## HIGHWAYS ADVISORY COMMITTEE

**DOGGETT'S CORNER  
PROPOSED X-CROSSING**  
Outcome of public consultation

This report sets out the responses to a consultation for the addition of an X-crossing pedestrian stage at the signalised A124 Upminster Road/ Hacton Lane/ Wingletye Lane junction and seeks a recommendation on the implementation of a reduced scheme to provide an additional pedestrian crossing stage at the junction with green men crossings on all arms.

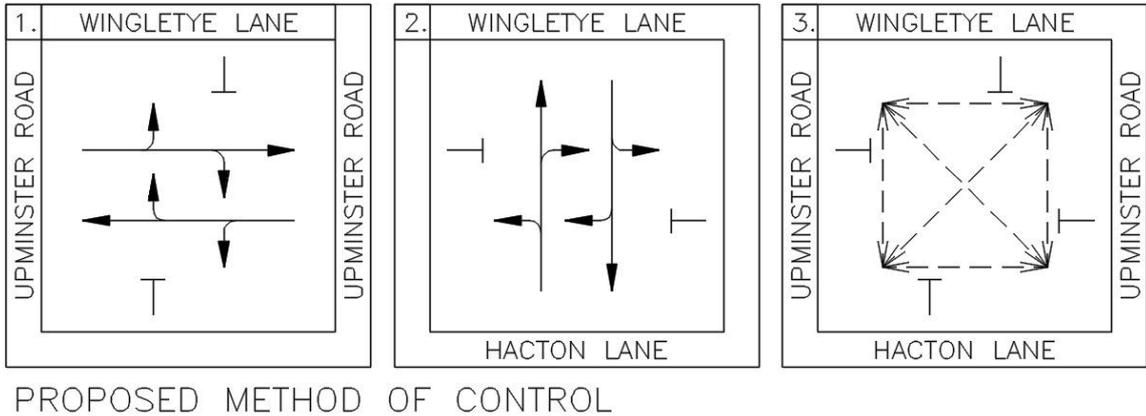
3.4 Those giving partial support all agreed that the arms of the junction should be provided with "green men" crossings, but disagreed with the X-crossing and additional comments are summarised as follows;

- Concern about extra traffic delays/ congestion
- Drivers often jump the lights
- General concerns about rat-running
- Request for non-related scheme
- Right turning traffic needs its own phase
- Red light cameras are required
- Diagonal crossings will remove safety barriers

3.5 Those objecting to the proposals did so outright, with many adding comments to support their objection. The issues which were cited more than once are summarised as follows (in order of frequency);

- Concerned about impact on traffic congestion
- Does not consider it difficult for people to cross
- Concerned about rat-running, including Minster Way and Glanville Drive
- Money should be spent on something else/ waste of money
- 6th Form students already have a crossing outside the college
- Junction should have right turn filters
- Dangerous design

4.10 Therefore, taking into account the scheme objectives and needs of pedestrians, the issues raised through the public consultation process and the advice of Transport for London, Staff recommend that a third, pedestrian, stage be implemented as shown on the diagram in paragraph 4.9 above and on QQ025-DC-FS-GA-100-REV1, and the scheme be monitored accordingly.

REVISED PROPOSED METHOD OF CONTROL

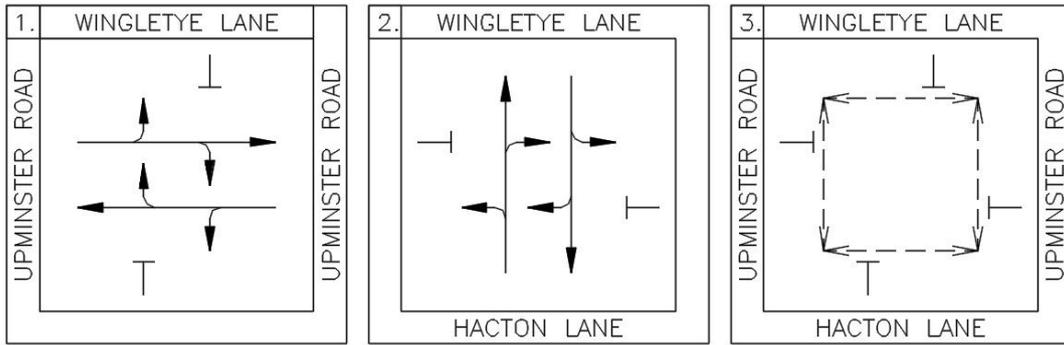
3.6 Transport for London's network performance team had some concerns with the X-crossing arrangements, specifically the pedestrian crossing/ clearance time associated with the diagonal crossings. Their concern extended to bus travel times through the junction. They however noted the current lack of pedestrian crossing assistance at the junction.

- 4.7 Those objecting to the scheme and those supporting signalised crossings, but not the X-crossing raise concerns about traffic congestion. As set out above, Staff have been working closely with Transport for London’s traffic signal engineers and network performance engineers as the scheme detail has been developed. TfL’s concerns about the diagonal crossings have been noted.

- 4.8 TfL estimates that the introduction of a third stage for pedestrians could increase traffic delay by approximately 20%, however given that the site is within the wider SCOOT network, they would be able to mitigate this to a certain extent with a thorough timing review and fine-tuning the SCOOT operation.

- 4.9 TfL further estimates that the addition of the diagonal crossings would significantly increase delay, including to pedestrians using the new third stage. Delay does not present itself linearly, but rather exponentially. TfL’s recommendation is that notwithstanding the desirability of providing diagonal crossings, the simpler arrangement on the arms would be easier to introduce and manage in capacity terms. The method of control would be as follows;
